To: Sam Bohannon, Ingram Civil Engineering
From: Pat O'Mahony, Associate Planner; 910-341-0189
CC: File;
Date: 10/23/2019
Re: Wilmington Treatment Center, Phase II TRC Rev. 1

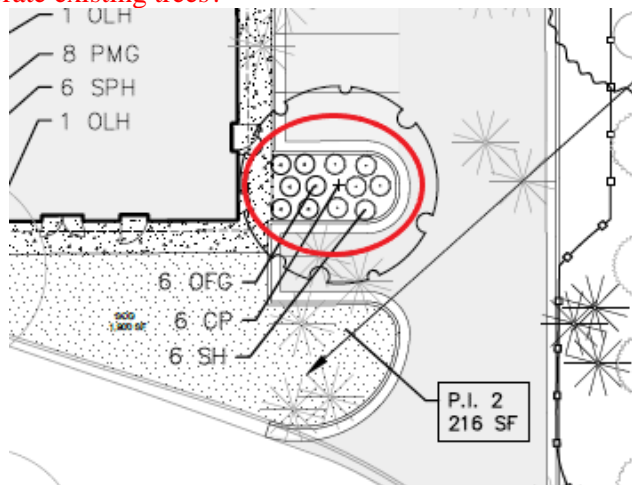
- Comment: Can the area highlighted below be moved further south to incorporate existing trees?
